Q3-DFBX Interconnect Procedure Attachment 1

ITEM	PART NO.	DESCRIPTION OR SIZE	QTY.
PARTS LIST			
UNLESS OTHERWISE SPECIFIED	ORIGINATOR	P, PFUND	
1. XXX	UNLESS OTHERWISE SPECIFIED	K, KWALD	10/21/03
2. L	CHECKED	P, PFUND	10/22/03
3. APPROVED	APPROVED	P, PFUND	10/22/03
4. MATERIAL	USED ON		
FERMILAB NATIONAL ACCELERATOR LABORATORY UNITED STATES DEPARTMENT OF ENERGY			
LHC INNER TRIPLET INTERCONNECT DFBXC-Q3/DFBXG-Q3 DETAILED LAYOUT			
SCALE	FILING	DRAWING NUMBER	REV.
NONE		5520-ME-432010	B

MODIFIED DETAIL VIEWS

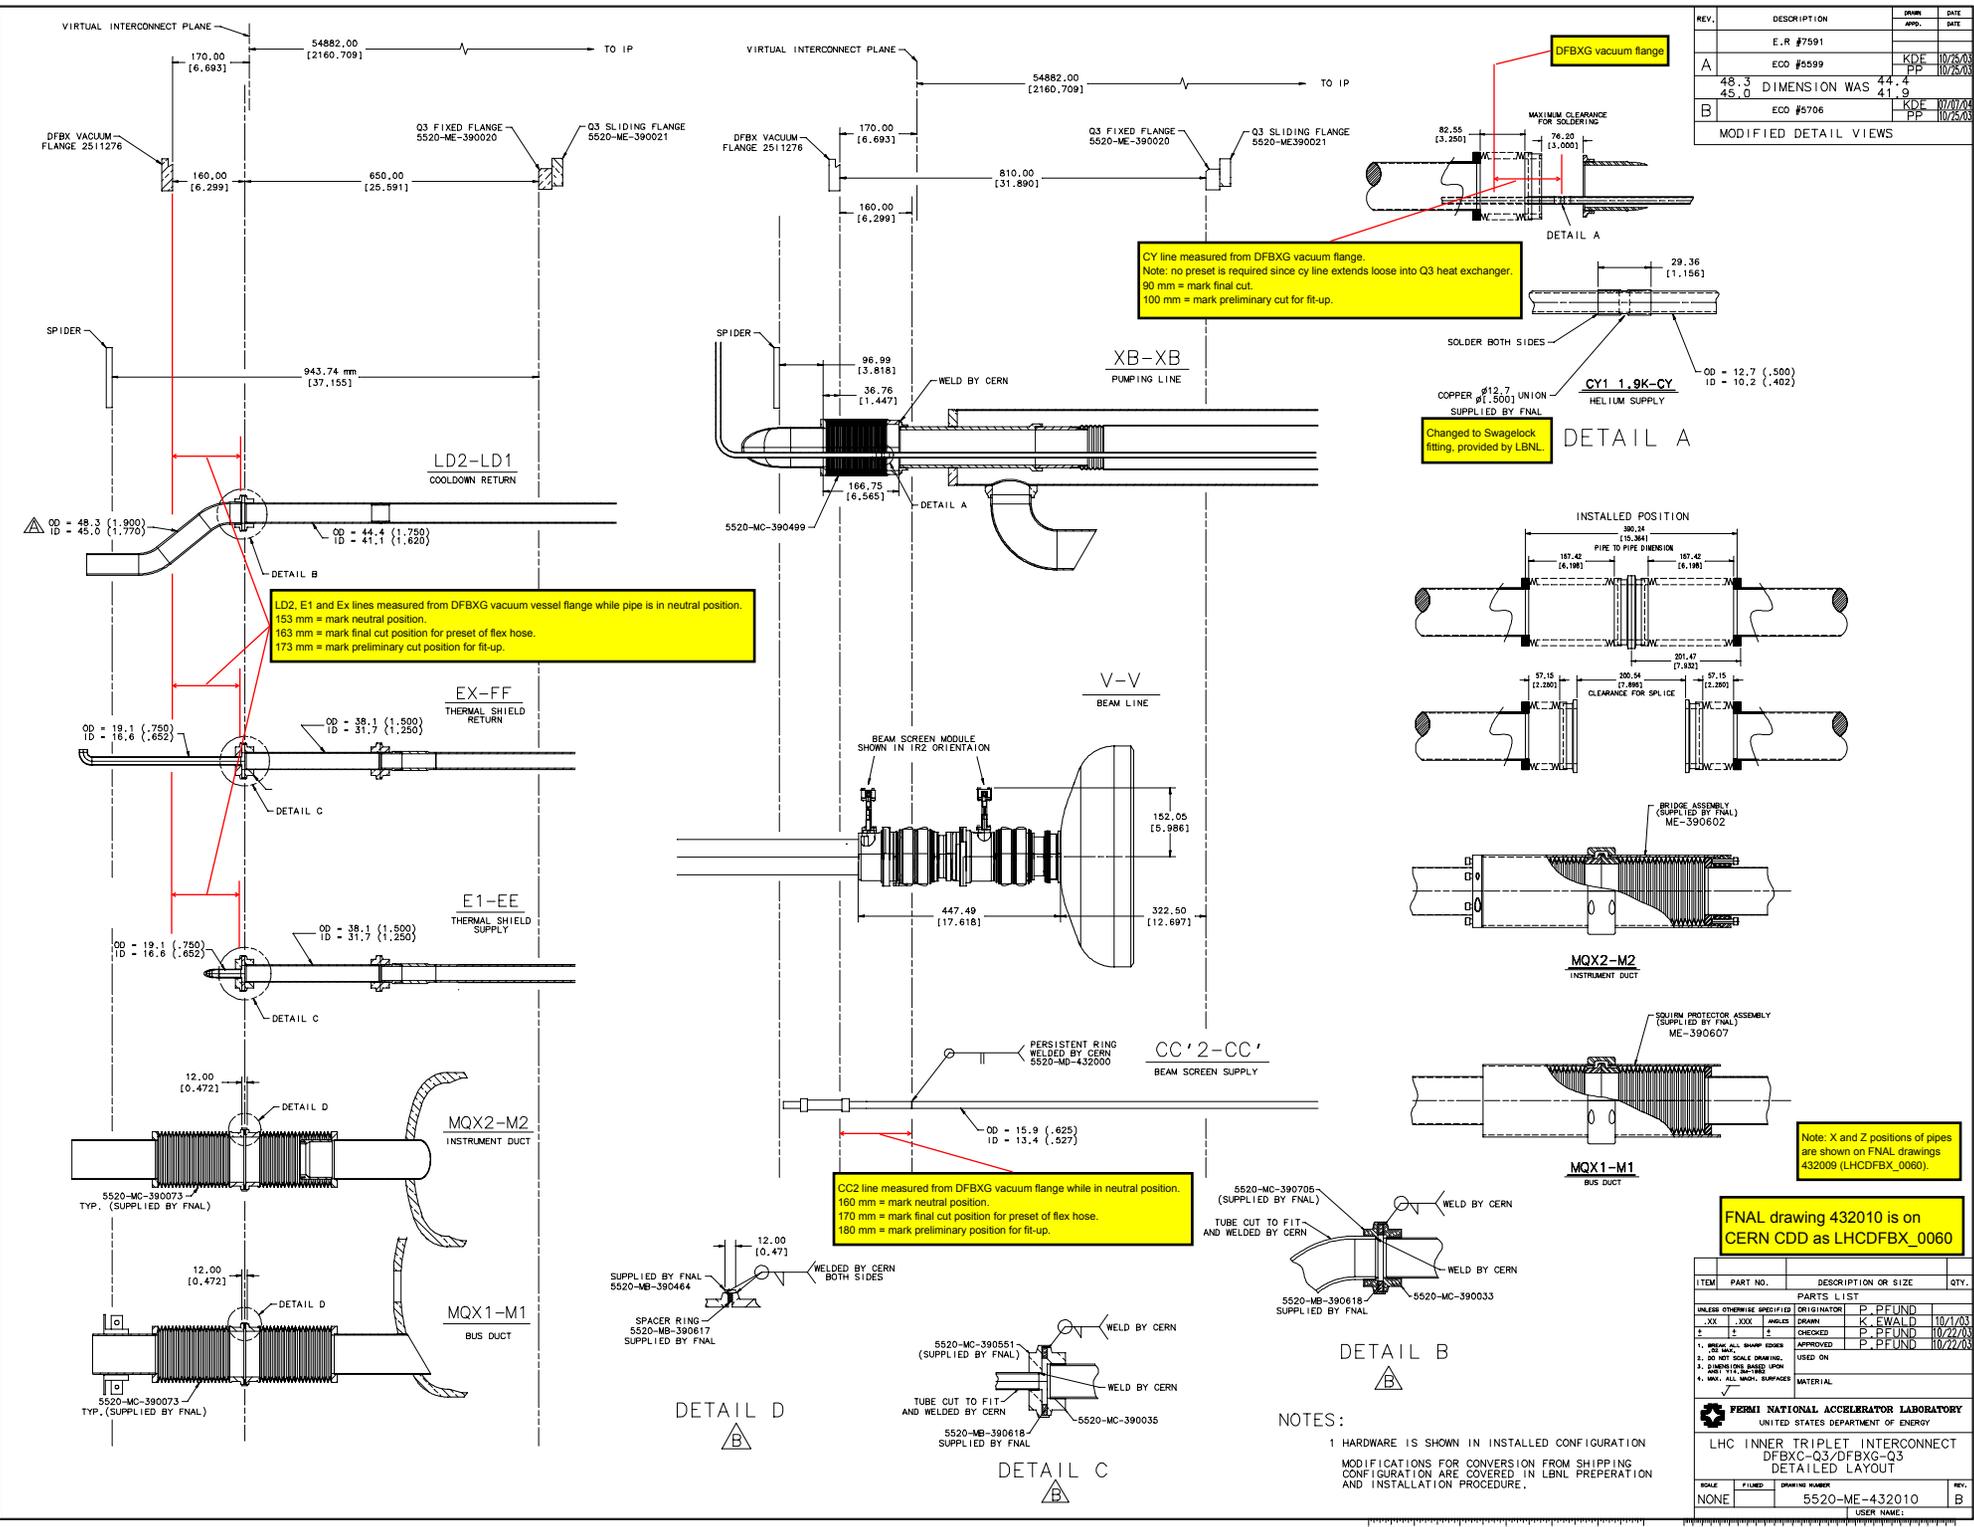
REV.	DESCRIPTION	BY	DATE
	E.R #7591		
A	ECO #5599	KDE	10/22/03
	48.3 DIMENSION WAS 44.4	PP	
B	ECO #5706	KDE	10/22/03
	45.0 DIMENSION WAS 41.9	PP
